BLANKENSHIP'S ADDITION TO KINGSWOOD **SUBDIVISION**

APPLICATION NUMBER 21 DATE April 2, 2009
APPLICANT Blankenship's Addition to Kingswood Subdivision
REQUEST Subdivision

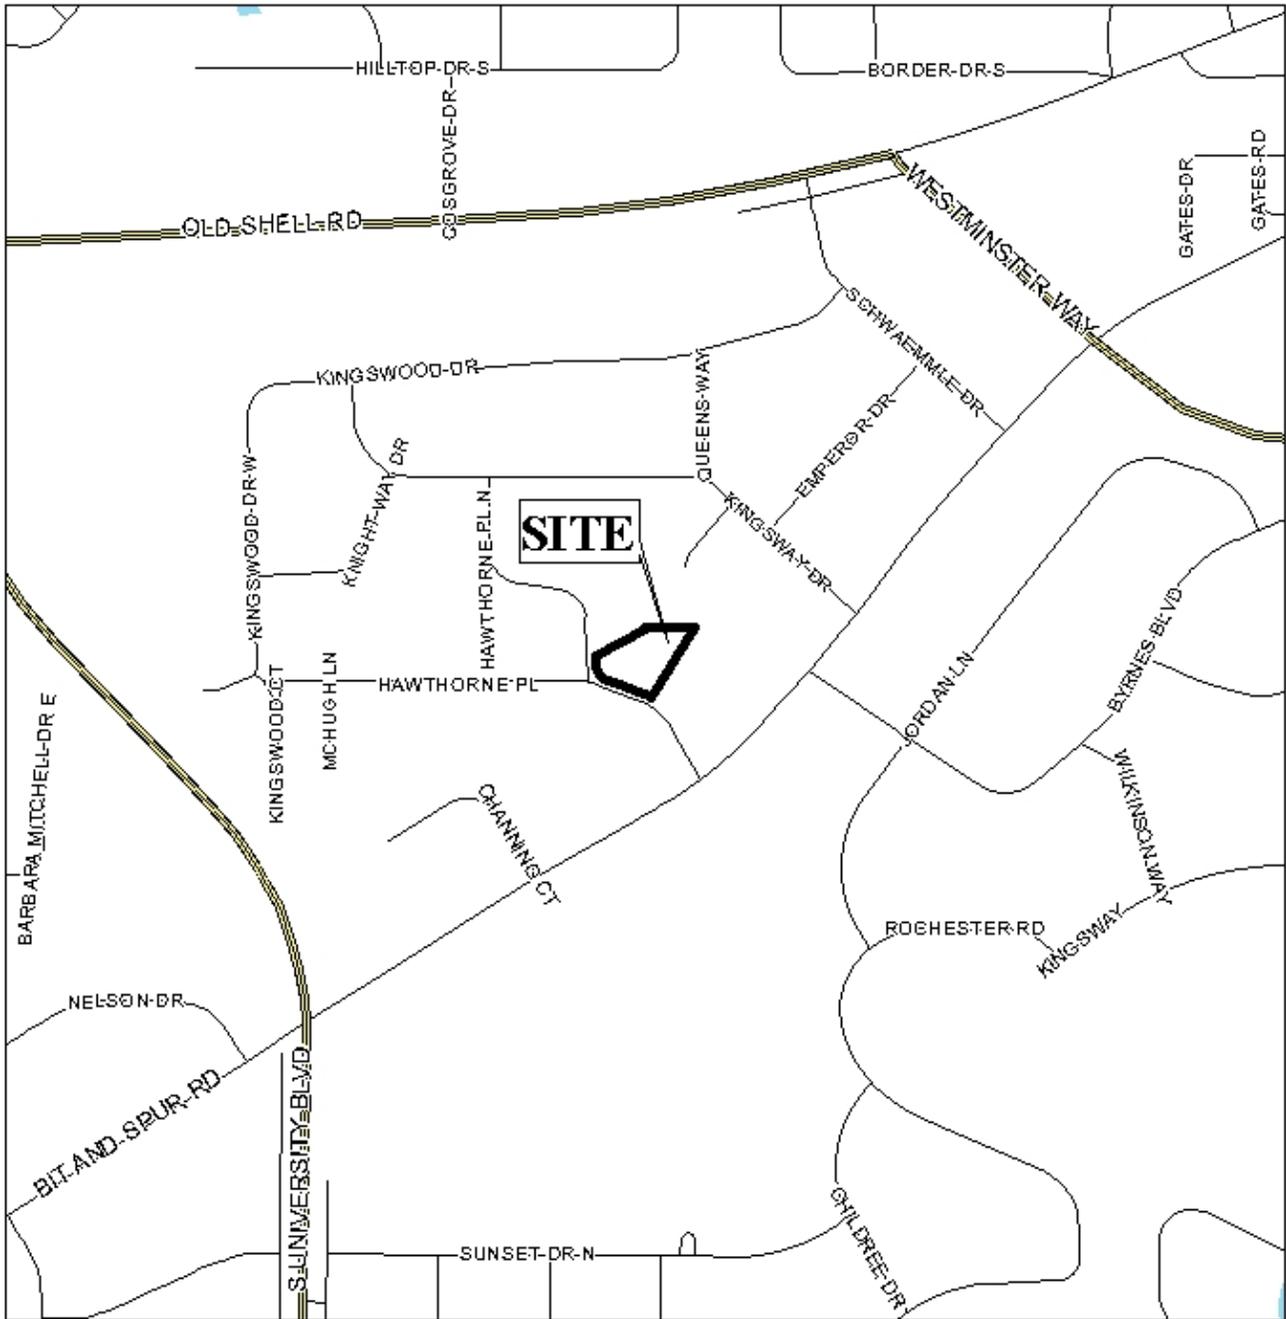
The plat illustrates a lot of adequate size and adequate public right-of-way access to meet the minimum requirements of the Subdivision Regulations. The plat, however, also illustrates that the proposed Lots B and C do not meet Section V.D.3 of the Subdivision Regulations regarding maximum depth of lots. The proposed Lot B is approximately 63 feet wide at the building setback line. The maximum allowable depth under Section V.D.3 is 220.5 feet. As depicted, the depth of the lot is 240 feet. The proposed Lot C is approximately 60 feet wide at the minimum building line, giving it a maximum allowable depth of 210 feet. The depicted depth for the proposed Lot C is 258 feet. Lots not meeting the depth to width ratio do not appear to be characteristic for this area. Indeed, even the previous Cole's Addition to Kingswood which was approved by the Commission in February, 2007, did not include lots that exceeded the maximum width to depth ratio.

Additionally, there also seems to be limited building site area for each lot, especially when side yard setback lines are considered. The lots also become increasingly smaller as the lots get deeper. In the cases of the proposed Lots A and C, the lots are each reduced to less than 50 feet in width in the rear of the lot, and the building area is reduced to less than 25 feet, in the case of the proposed Lot C and the less than 10 feet in the case of the proposed Lot A.

- 1) The proposed Lots B & C do not conform to Section V.D.3 of the Subdivision Regulations and appear uncharacteristic for the area; and
- 2) The limited building site areas for each lot.
